Caddick Developments, Knowsley

Response to LLFA Comments

Document No: 22075-BGL-XX-XX-TN-D-00001

The following technical note has been prepared by Burrows Graham Ltd. on behalf of their client Caddick Developments in response to the LLFA comments received in relation to application ref. 22/00348/FUL.

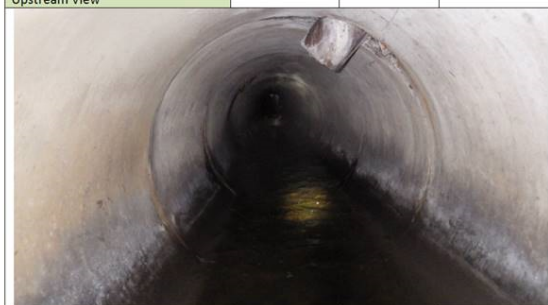
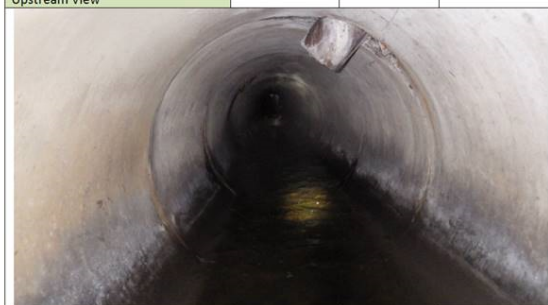
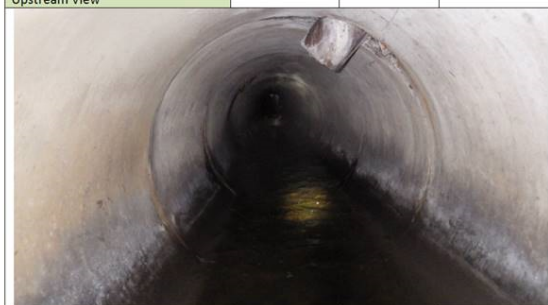
Should the discharge to the watercourse will be retained in the final design, a survey of the watercourse within the site and the culvert under Ormskirk Road will be required. Free flow conversance from the site to the outfall in Knowsley Brook should be demonstrated by a dye test. The reach from the outlet of the proposed attenuation pond to the Knowsley Brook should be modelled using blockage scenarios (up to 70%) of the culvert under Ormskirk Road for events up to the 100 years plus 40% climate change.

As confirmed in the FRA, a dye test has been carried out by JBA which confirms the connectivity from the site watercourse to the Knowsley Brook (as shown below on the connectivity drawing and culvert CCTV). Blockage modelling has previously been undertaken by the EA on the receiving watercourse / culvert under the A580 up to a blockage of 75%. A range of design events and climate change uplifts are also applied as part of this analysis. The site is not at risk of flooding in any of the scenarios considered.

Appendix D – Drainage Layout

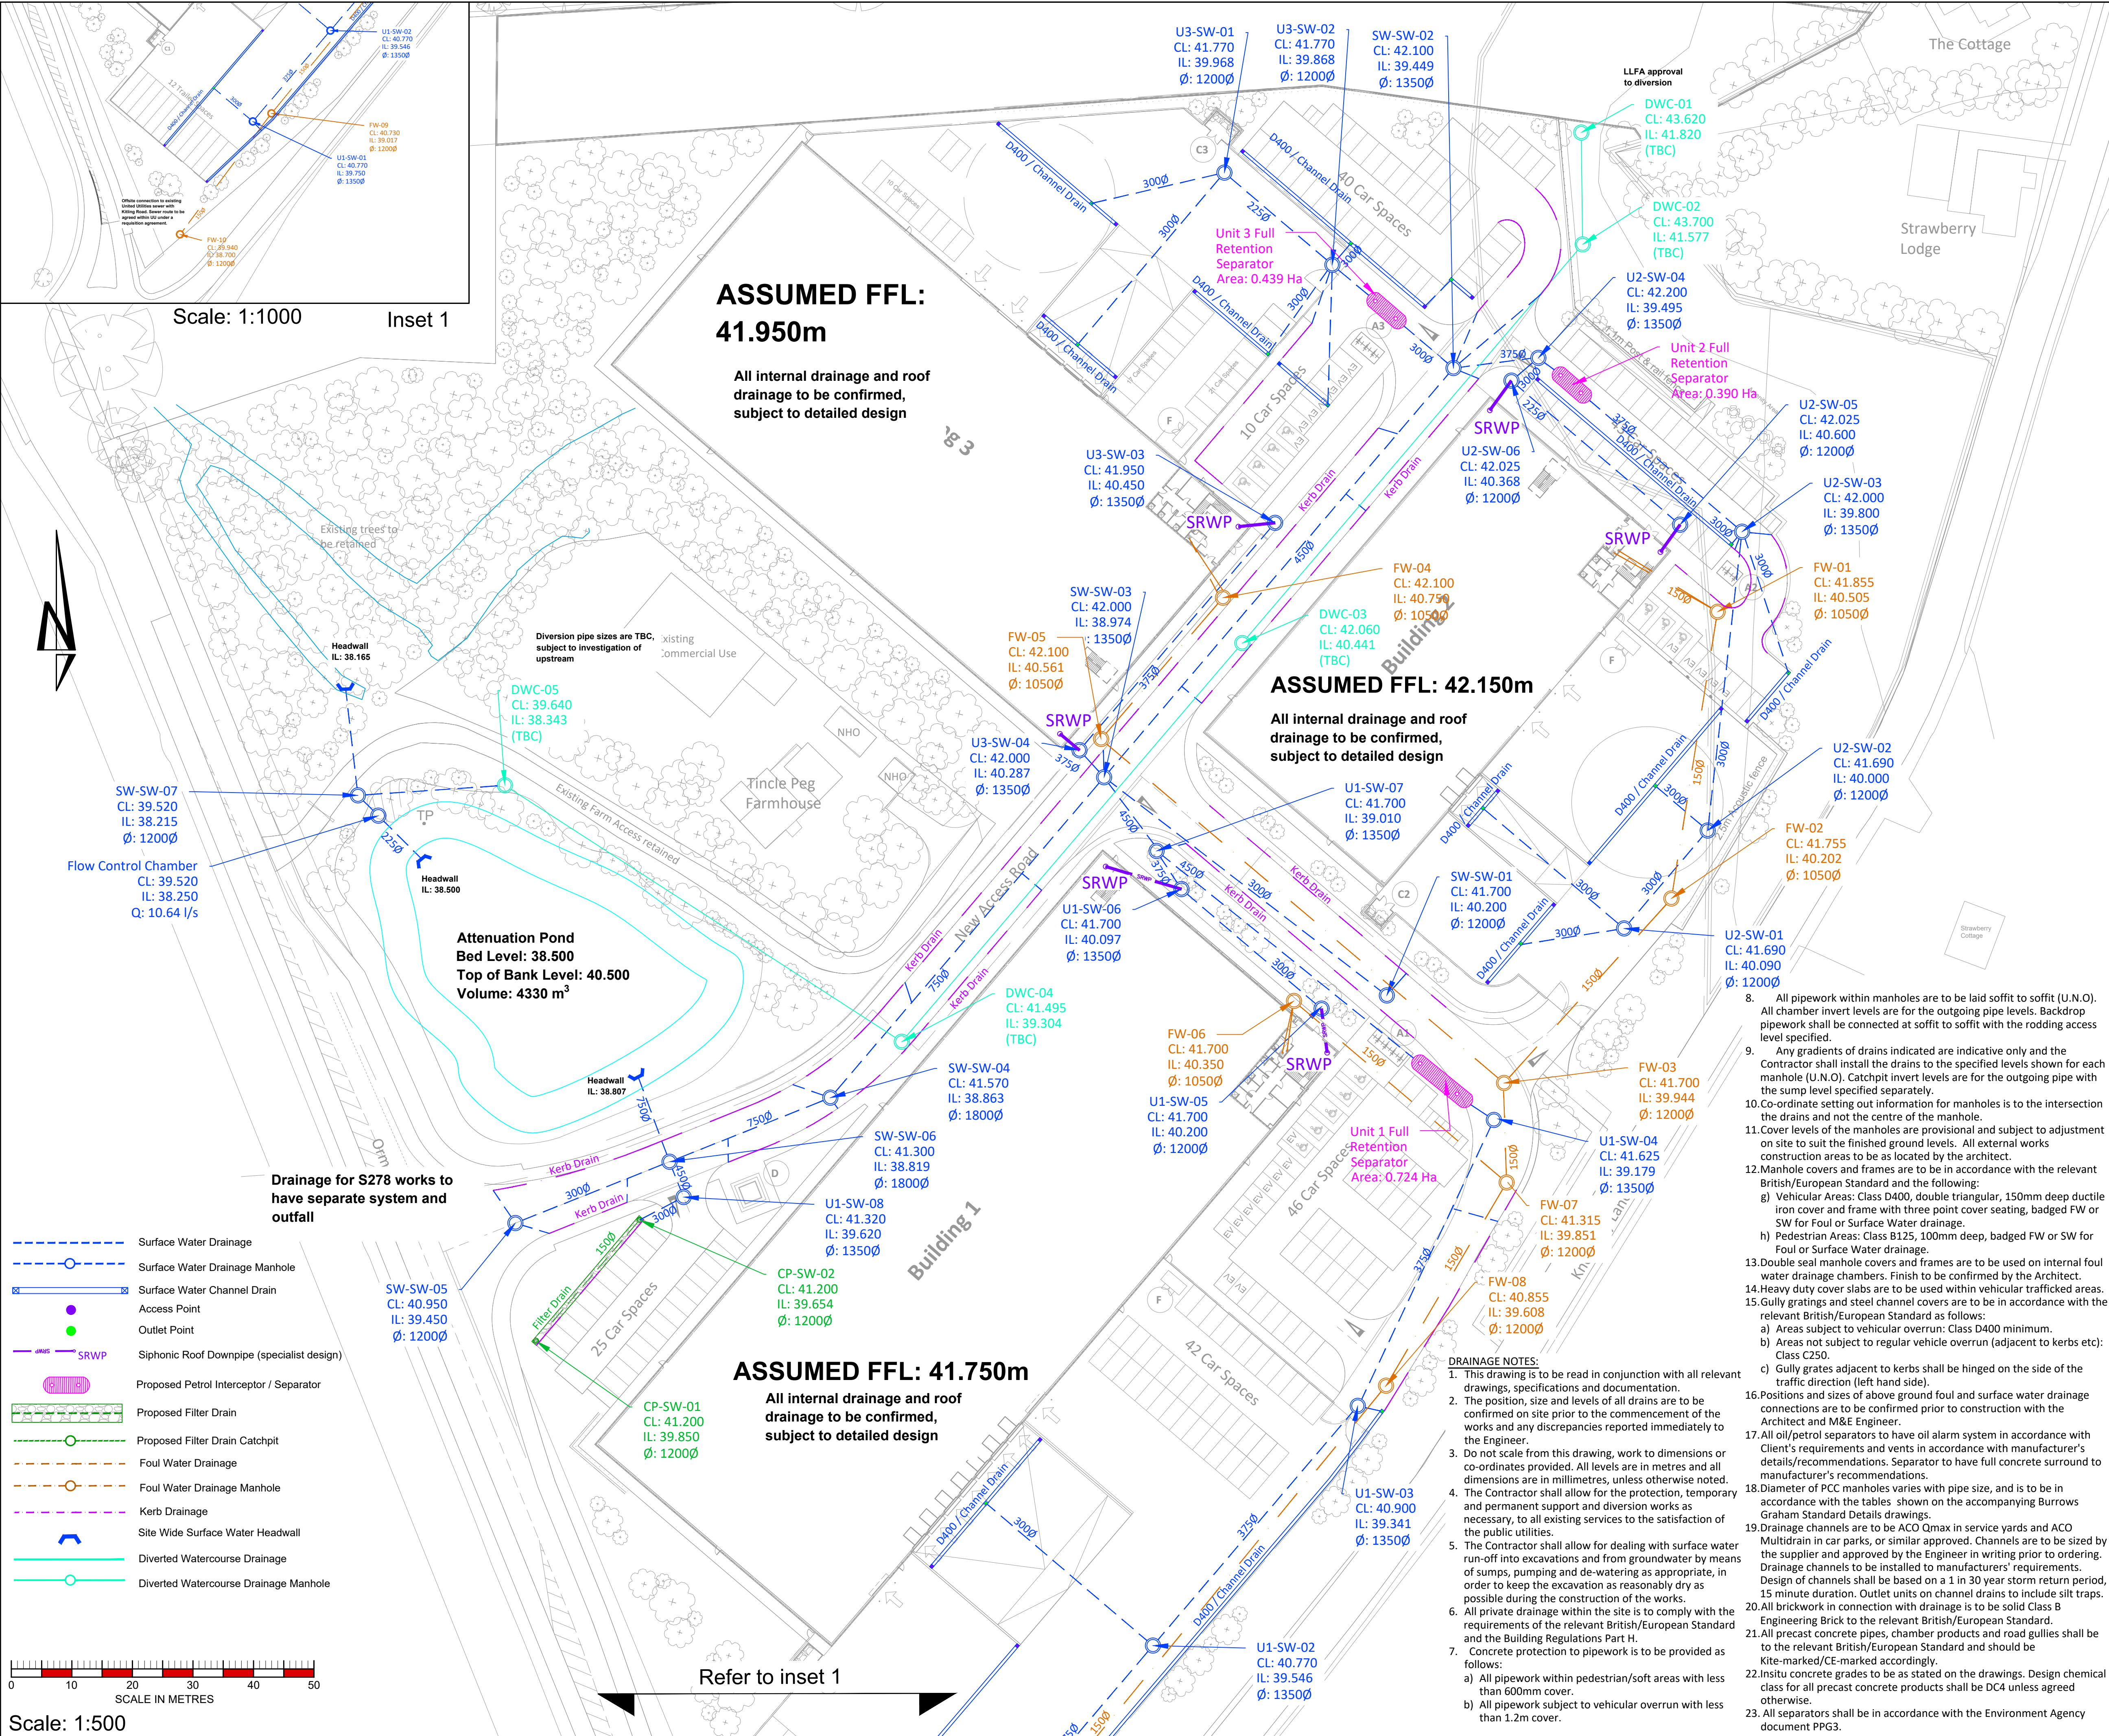
Exceedance routes of surface water should be provided for the post development situation;	Exceedance flow path drawing is shown in Appendix B. This shows minor flooding contained on site for the 100 year plus 40% climate change event. We consider this acceptable.												
An evaluation of impact of potential failure of the drainage system (including risk assessment)	To be conditioned as part of maintenance plan.												
The feasibility and adequacy of the proposed drainage system under 1 in 2, 1 in 30, 1 in 100, and 1 in 100 plus 40% climate change impact should be simulated using Micro Drainage or similar approved hydraulic models	Hydraulic calculations provided within Appendix C.												
Detailed drainage scheme plan that shows the layout of the proposed drainage network, post development impermeable area, post development catchment areas to each SUD feature, location of storage (incl. connection points);	Detailed drainage layout within Appendix D. The manhole references are linked to the flow results in Appendix C.
